Technical Service Bulletin: tsb100555

Released Date: 30-Jan-2007

Modified Lubrication Oil Centrifuge

New Radius on Rotor Balancing Notch

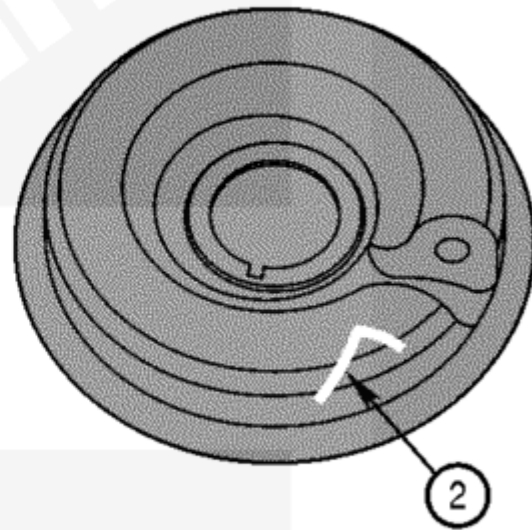
This Technical Service Bulletin describes a modification carried out on the lubrication oil centrifuge, Fleetguard Part Numbers 389497500S, CH4410500, and CH4412000, fitted to some QSK60 Construction series engines. This modification resolves an issue of high oil pressure spikes within the centrifuge and subsequent rotor cracking. The balancing notch on the rotor turbine has been modified to include a radius which lowers the stresses and eliminates the cracking. The centrifuge oil supply **must** be tapped after the full-flow lubrication filter(s) (clean side) to eliminate potential issues of high oil pressure spikes, which can be detrimental to centrifuge performance.

1. Radius.

Modified Lubrication Oil Centrifuge

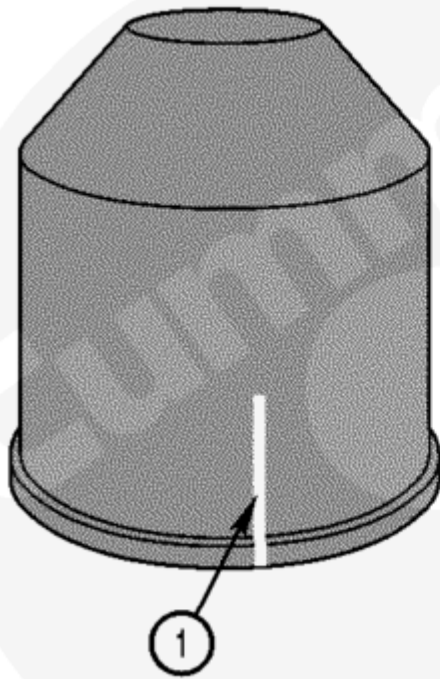
No part number change was required. Fleetguard® have marked the modified rotor assemblies with a white line on the outside of the turbine can as well as a white check mark on the bottom of the centrifuge.

1. White line on outside of turbine
2. White check mark on bottom of centrifuge.
